FOOTHILLS WATER NETWORK

**RE: COMMENTS ON PLACER COUNTY WATER AGENCY'S
DRAFT LICENSE APPLICATION FOR THE MIDDLE FORK AMERICAN
HYDROELECTRIC PROJECT #2079**

The Foothills Water Network submits this letter in response to Placer County Water Agency's September 27, 2010 submission of its Draft License Application for project # 2079.

Figure O-15. Middle Fork American River MF14.1 Effective Food Production Habitat Matrix.

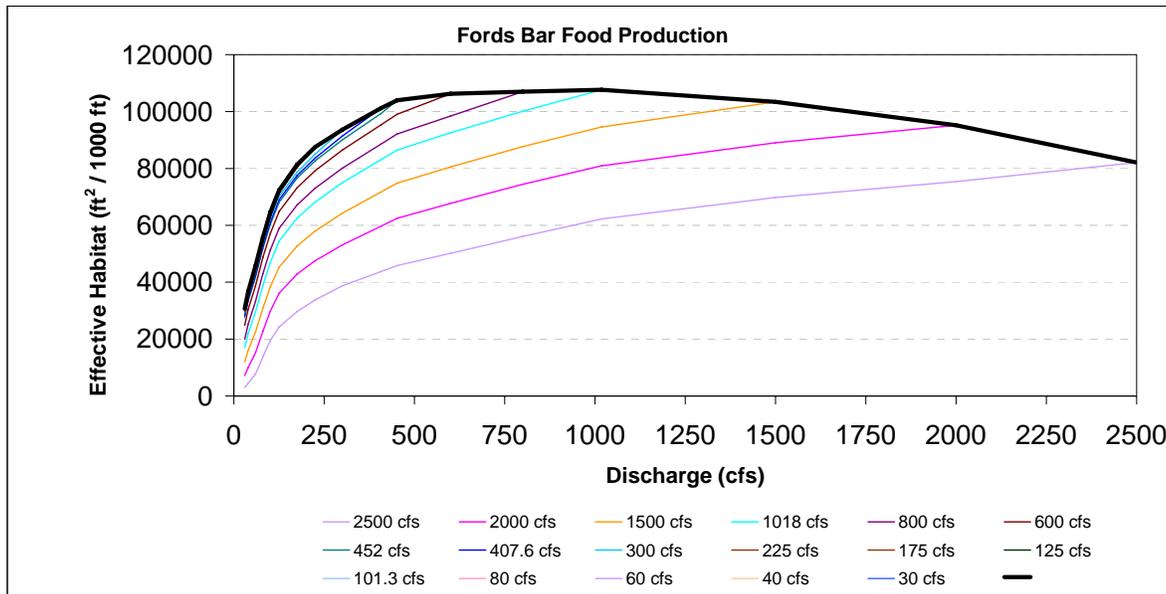
The Foothills Water Network recommends that PCWA include conditions in its FLA that reduce flow fluctuations in the Peaking Reach to increase benthic macroinvertebrates (BMI) populations and food production for fish. Based on PCWA's Effective Food Habitat Matrices for the Peaking Reach, food production increases as the magnitude of flow fluctuations decrease.¹⁰ (See Appendix C for AQ1-Instream Flow Study Report, Figure O-15 and O-24 Middle Fork American Effective Food Habitat Matrices.) An increase in minimum instream flows from the PCWA DLA proposed minimum flows would increase food production and BMI habitat in the Peaking Reach.

The Network recommends that PCWA include an adaptive management clause in its FLA that if licensed flow regime studies indicate decreases or adverse trends in BMI populations, then PCWA will adapt instream flow regimes that provide for increases in BMI habitat and production.
